SUNDRY NOTICES AND REPORTS ON WELLS

UTE INDIANS A #14

PLUG AND ABANDONMENT PROCEDURE

Proposed P&A

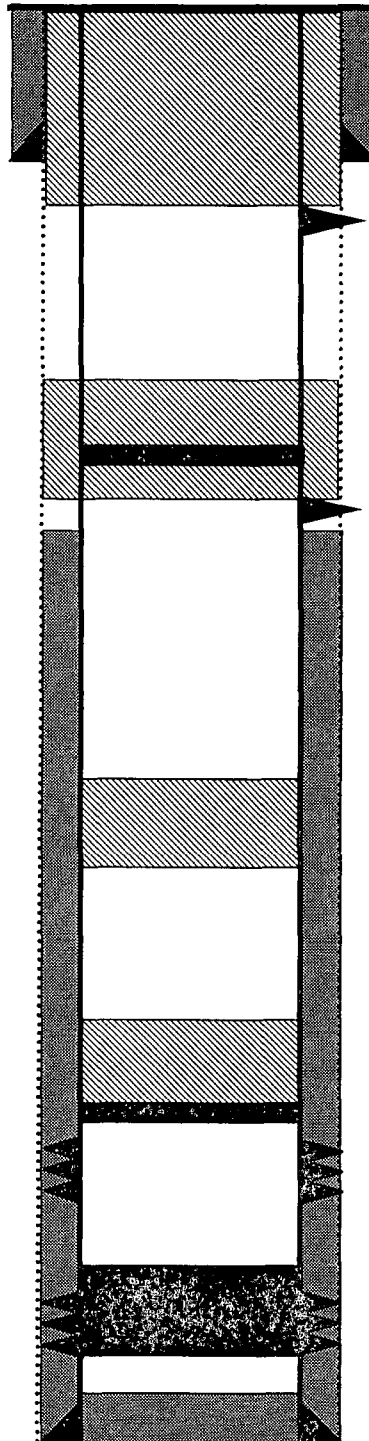
* Extend Mancos plug up to 1190'
